Product/Process Change Notice (PCN)

PCN #: PCN_WE-PD2_20160321
Product Affected: WE-PD2 series

PCN Date: 21st of March 2016
Effective Date: 21st of June 2016

Label example for pad printing
(13th digit marked in red)

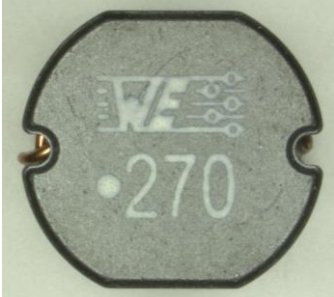
- 1.) Pad Printing and Laser-Printing will be used from now on.
- 2.) Printing method can be identified on the label by the 13th digit in the lot number.

Lot.-No. for Pad-Printing: xxxxxxxxxxxxx0xx
Lot.-No. for Laser-Printing: xxxxxxxxxxxxx2xx
